**Subject: Response to First Request for Additional Information  
Permit Application to Construct Phases I and II  
Vista Landfill, Class III (Facility ID 87081)  
Apopka, Florida  
(Permit No. SC48-0165969-014)**

Subject: Response to First Request for Additional Information  
Vista Landfill, Class III (WACS #87081)  
Permit Application No. SC48-0165969-019  
Orange County, Florida

Orange County – SW WACS # 87081  
Vista Landfill, Class III  
First Request for Additional Information  
Permit Application No. SC48-0165969-019

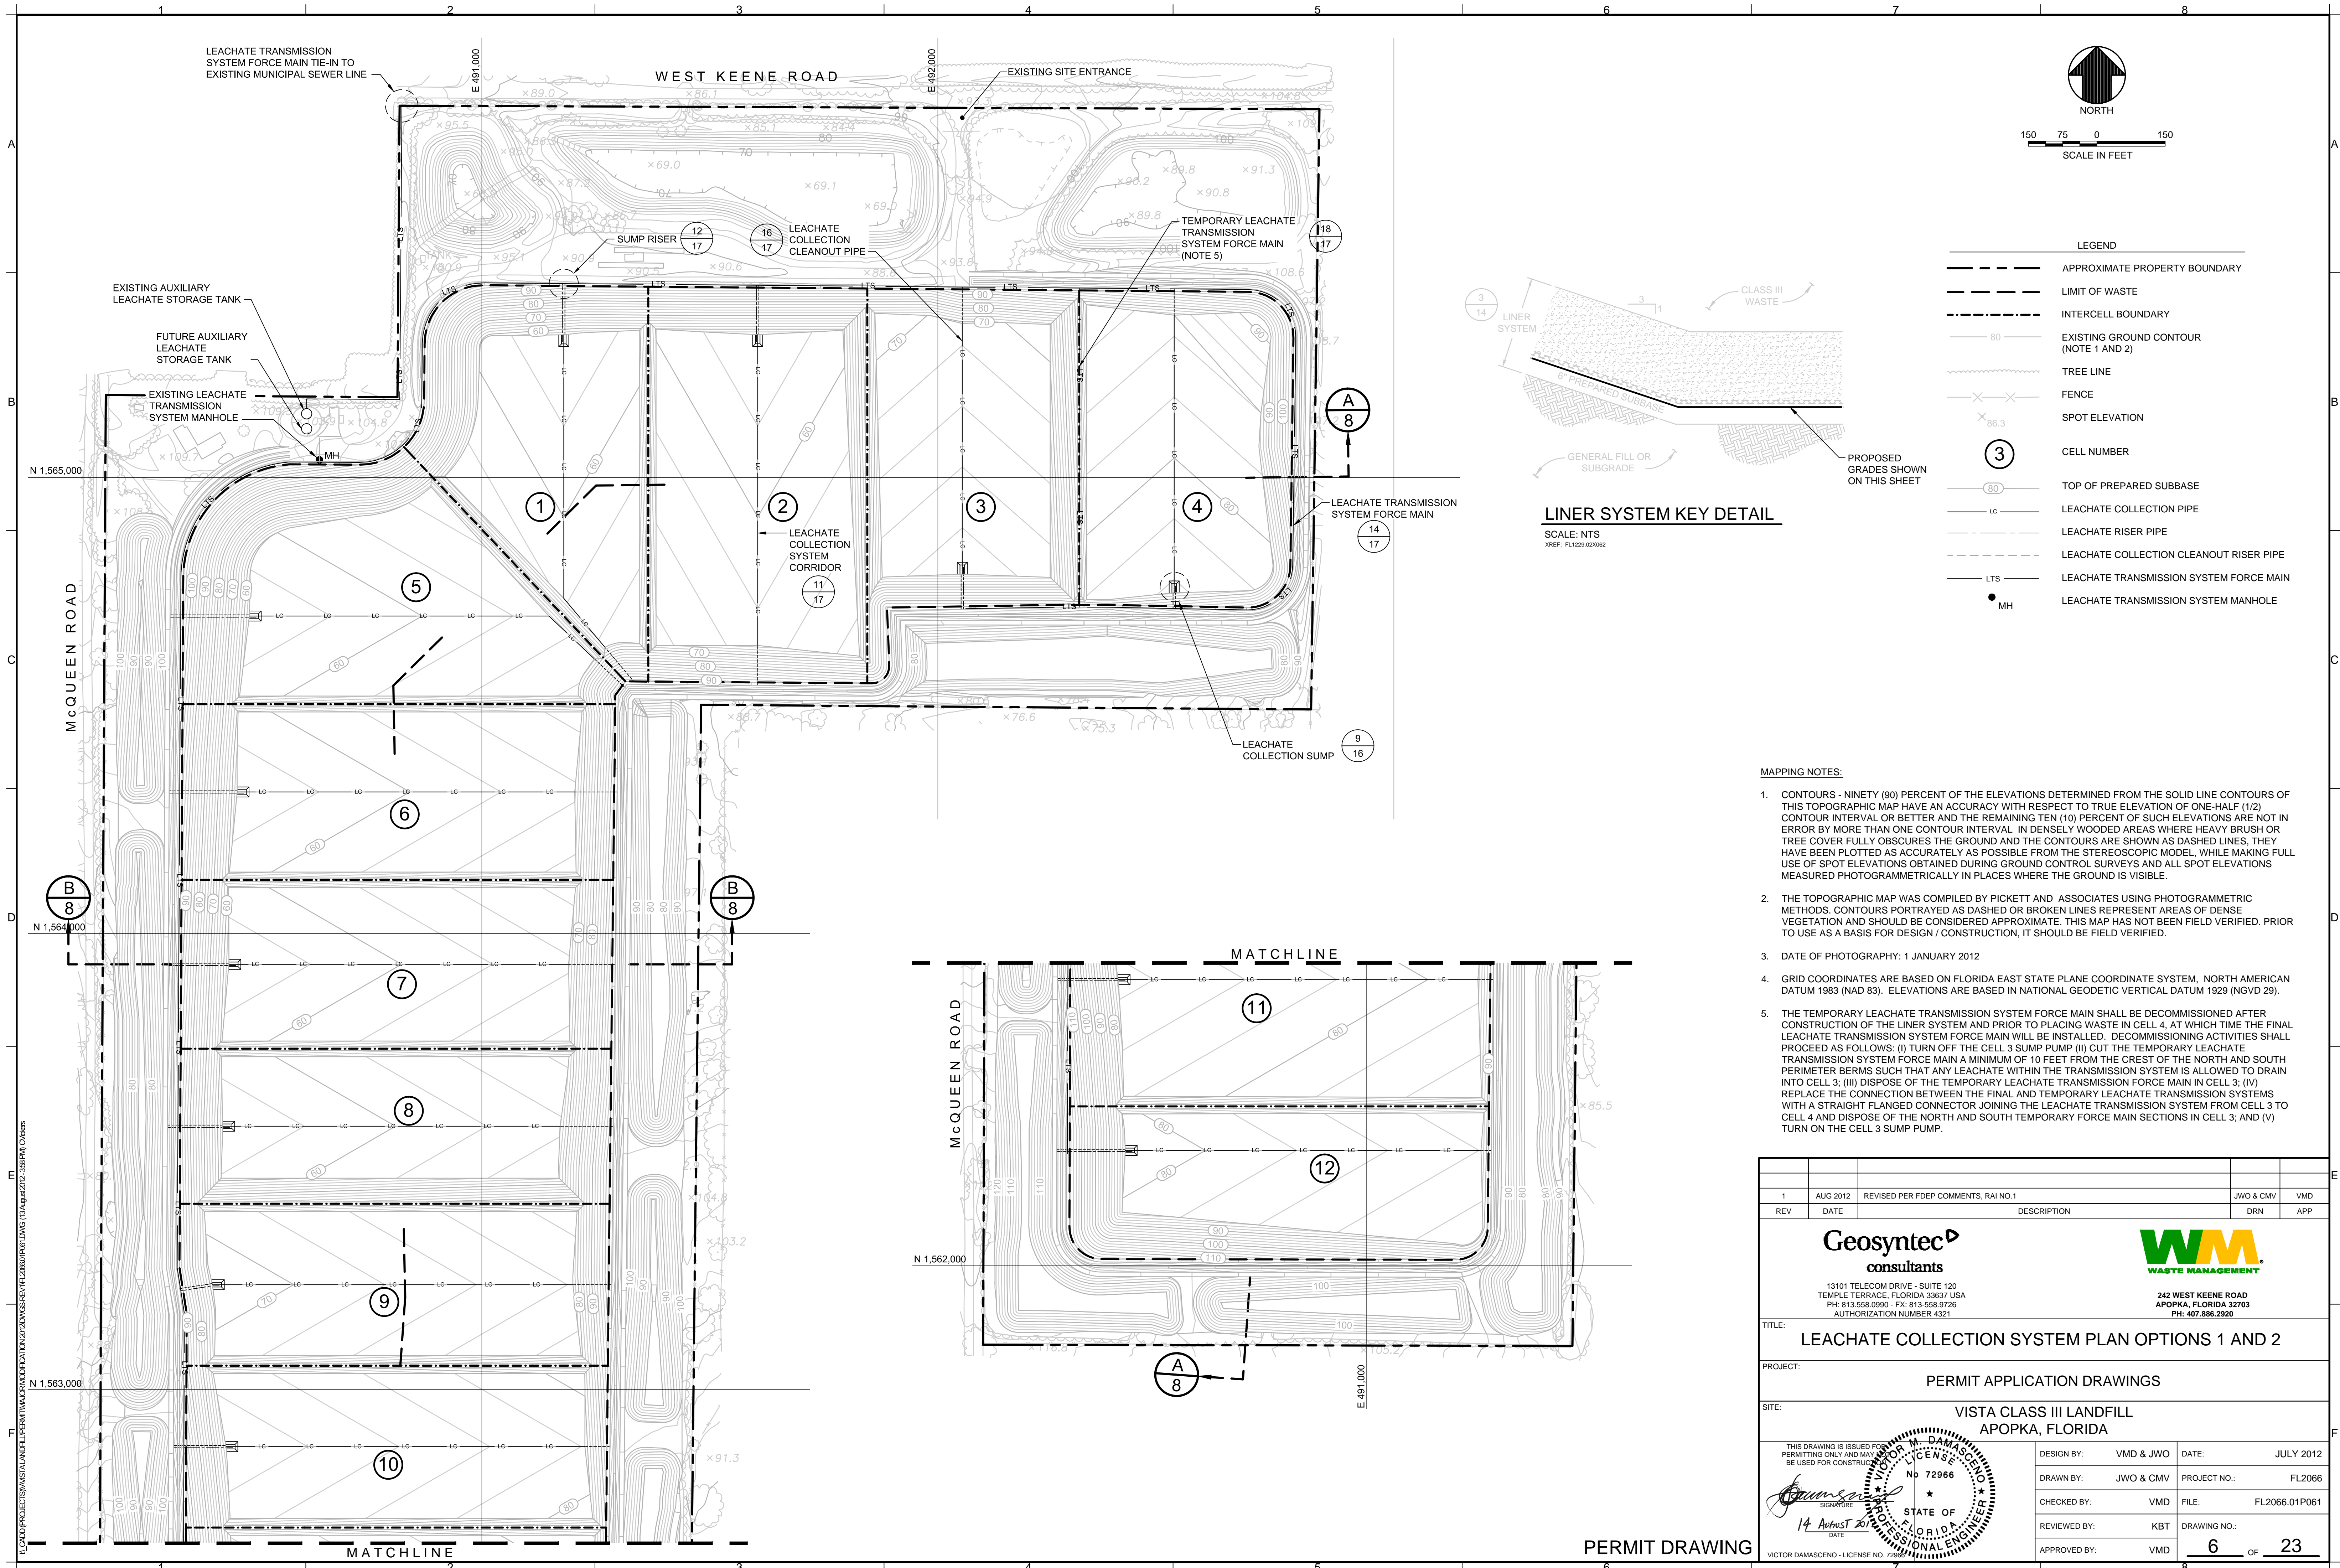
8. *Drawing 6, Leachate Collection System Plan, depicts a temporary leachate transmission system force main. Provide a plan for how the temporary main will be decommissioned which addresses the following:
  - a. *Describe how the temporary main will be drained.*
  - b. *Will the temporary main be capped and left in place or cut and removed?*
  - c. *When will the temporary main be decommissioned (that is, describe the events or operating conditions that lead up to the time when the main will be decommissioned, not the time frame when this will occur)?**

A note describing the decommissioning of the temporary leachate transmission system force main has been added to Sheets 6, 6A, and 6B of the Permit Drawing set. The updated/replacement drawing sheets are provided as part of Attachment B. Note that, as discussed during the meeting, the temporary leachate transmission system force main will be a dual-containment (i.e. 3-in. diameter HDPE primary (carrier) pipe and 6-in. diameter containment) piping system in lieu of the 6-in. diameter HDPE primary pipe described in Sheet

- THE TEMPORARY LEACHATE TRANSMISSION SYSTEM FORCE MAIN SHALL BE DECOMMISSIONED AFTER CONSTRUCTION OF THE LINER SYSTEM AND PRIOR TO PLACING WASTE IN CELL 4, AT WHICH TIME THE FINAL LEACHATE TRANSMISSION SYSTEM FORCE MAIN WILL BE INSTALLED. DECOMMISSIONING ACTIVITIES SHALL PROCEED AS FOLLOWS: (I) TURN OFF THE CELL 3 SUMP PUMP (II) CUT THE TEMPORARY LEACHATE TRANSMISSION SYSTEM FORCE MAIN A MINIMUM OF 10 FEET FROM THE CREST OF THE NORTH AND SOUTH PERIMETER BERM SUCH THAT ANY LEACHATE WITHIN THE TRANSMISSION SYSTEM IS ALLOWED TO DRAIN INTO CELL 3; (III) DISPOSE OF THE TEMPORARY LEACHATE TRANSMISSION SYSTEM FORCE MAIN IN CELL 3; (IV) REPLACE THE CONNECTION BETWEEN THE FINAL AND TEMPORARY LEACHATE TRANSMISSION SYSTEMS WITH A STRAIGHT FLANGED CONNECTOR JOINING THE LEACHATE TRANSMISSION SYSTEM FROM CELL 3 TO CELL 4 AND DISPOSE OF THE NORTH AND SOUTH TEMPORARY FORCE MAIN SECTIONS IN CELL 3; AND (V) TURN ON THE CELL 3 SUMP PUMP.

TITLE: **LEACHATE COLLECTION SYSTEM PLAN OPTION 3**

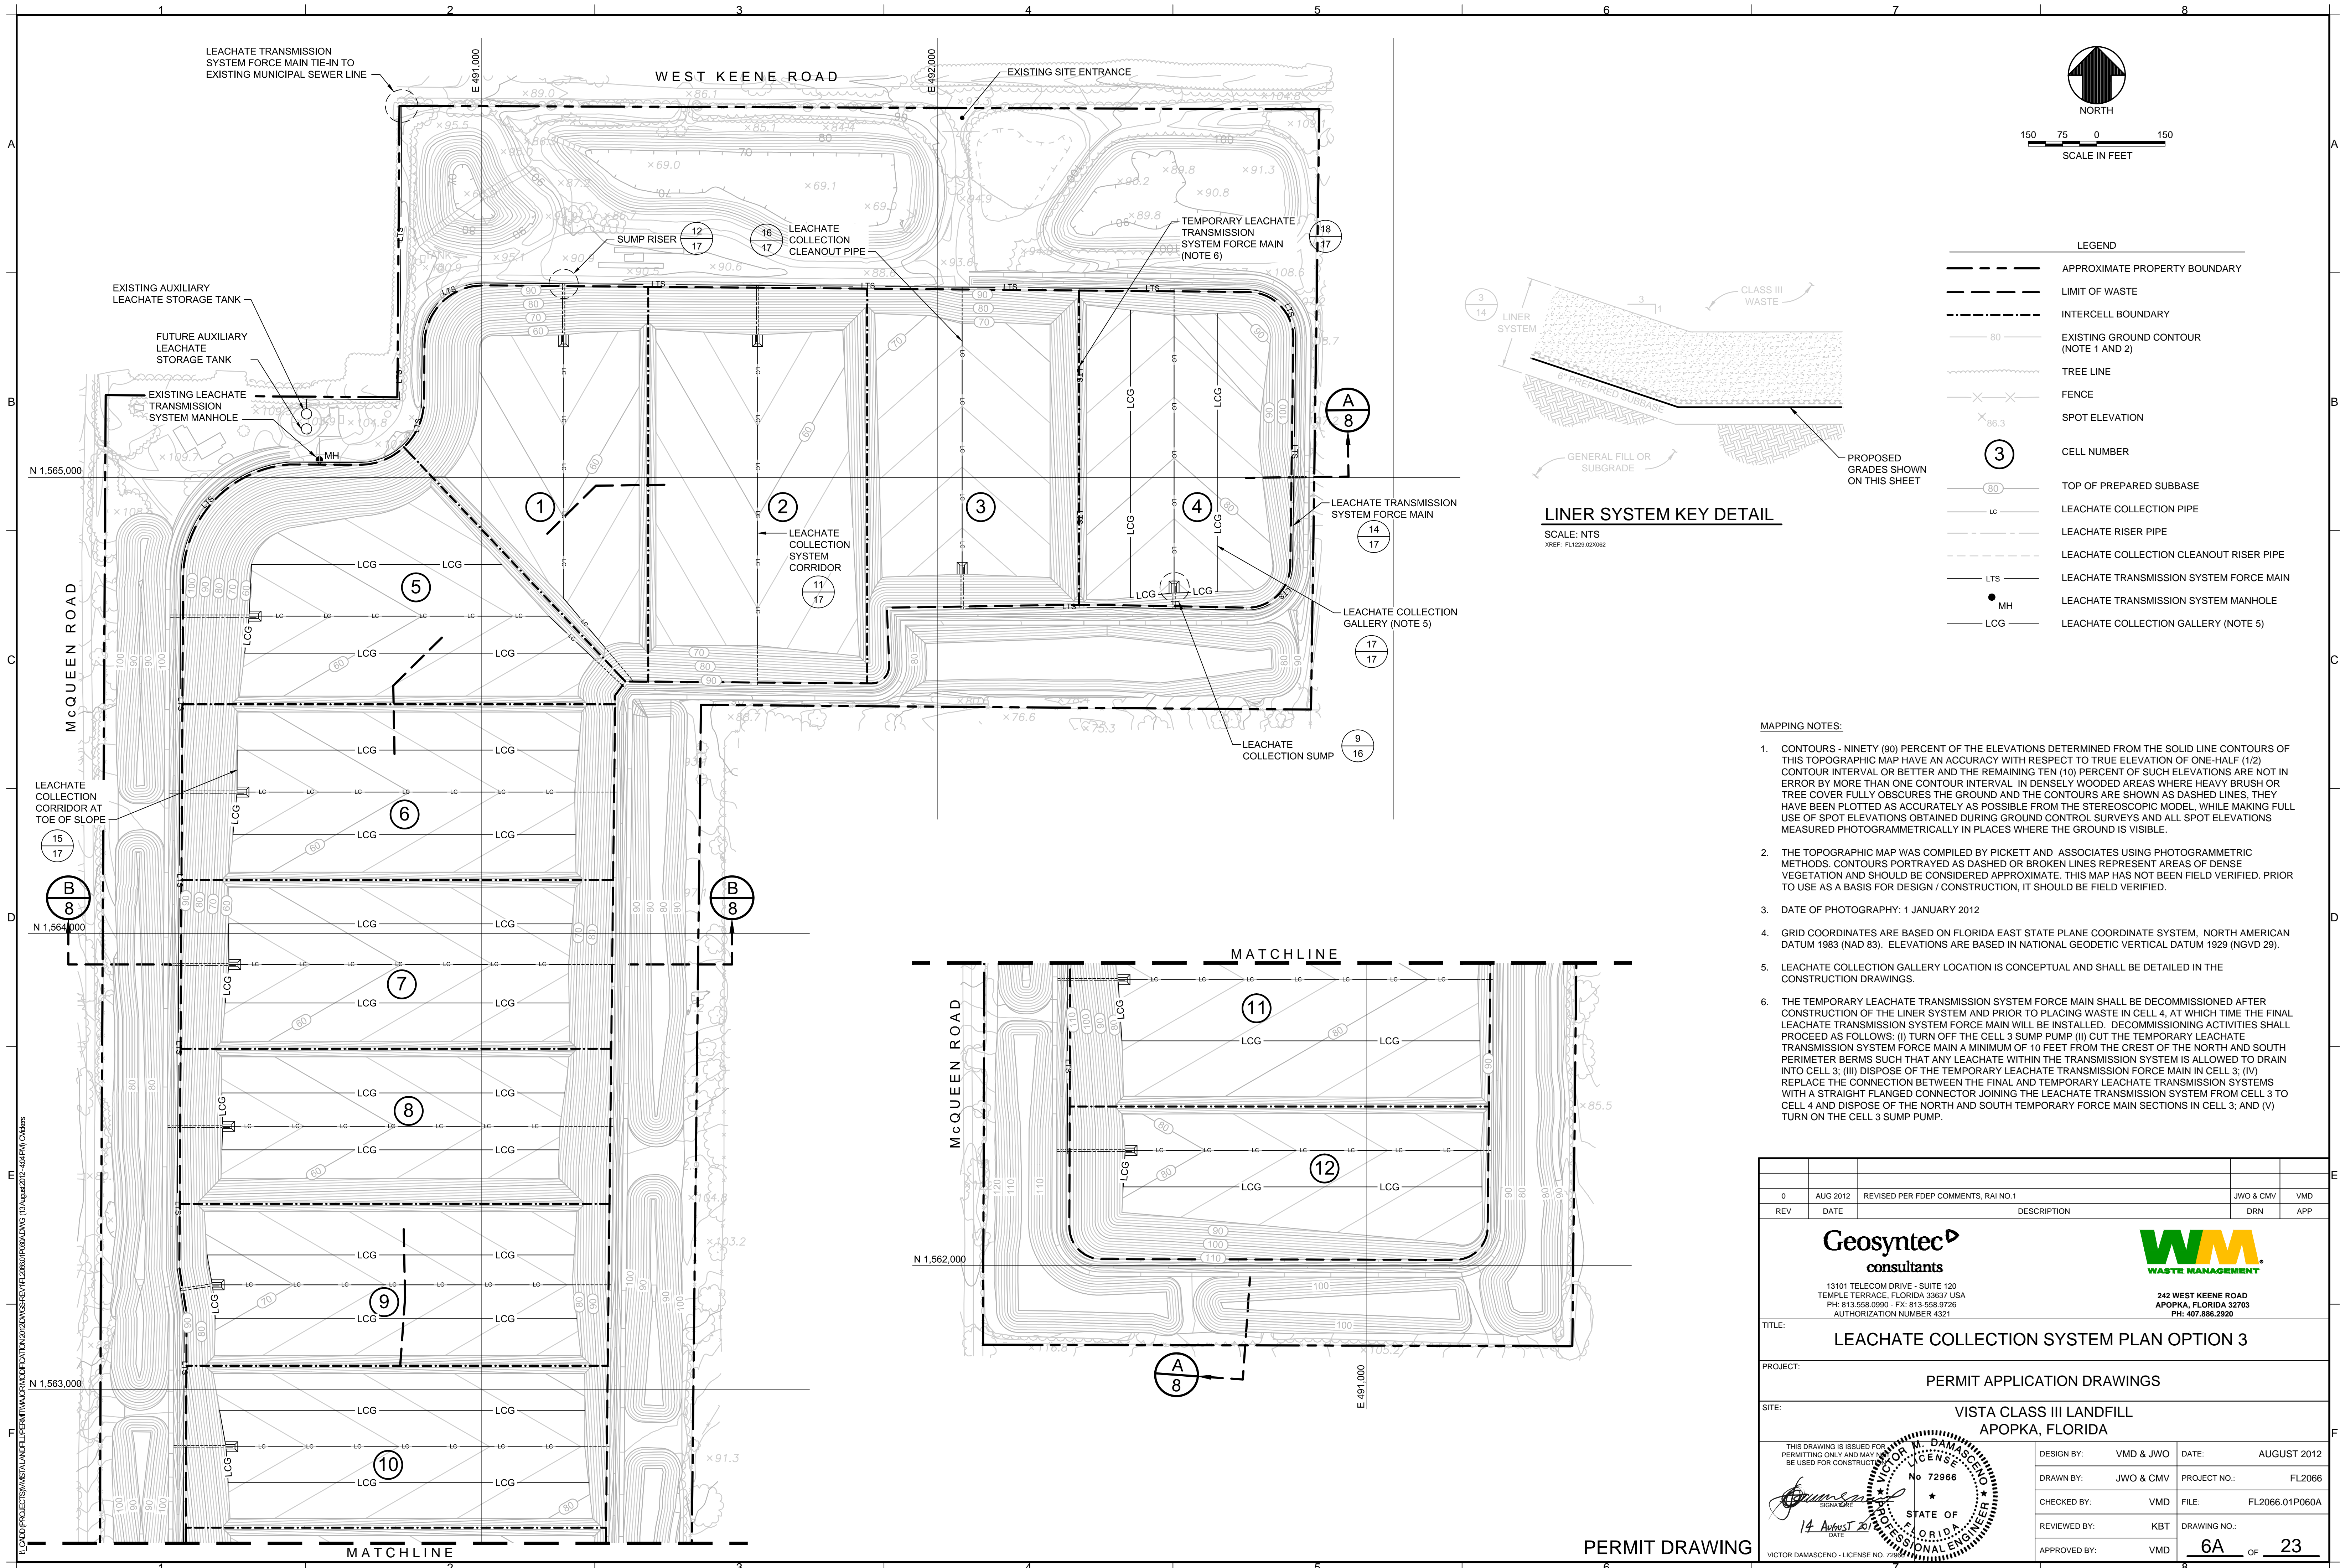
*Is the Department's understanding of the construction permit application correct? If yes, provide a separate drawing for each of the above options (the drawings should be similar to*

*Drawing 6 in the report). The drawings should refer to the corresponding details on drawings 14 and 17. If no, please describe each design and make sure there is a separate drawing for each one.*

FDEP's understanding of the construction permit application is correct; there are four potential layouts for the leachate collection system at the Vista LF facility, two of which are conceptual (i.e., Options 3 and 4). The permit drawings submitted with the 12 July 2012 Permit Application have been revised and replacement sheets are provided as Attachment B of this letter as agreed upon during the meeting. Two additional sheets (6A and 6B) have been prepared and are included with the revised replacement sheets in Attachment B.

As discussed during the meeting, the leachate collection gallery design varies with each cell based on the drainage length and properties of the sand. Therefore, the cross sections provided in the revised permit drawings have been updated to provide a conceptual design for the galleries (i.e., no dimensions for the width of the leachate collection galleries are provided). A minor permit modification will be submitted to FDEP for approval prior to cell construction should WMIF choose to pursue Options 3 or 4. Note that, as stated during the meeting Cell 3 will be constructed using Option 1.
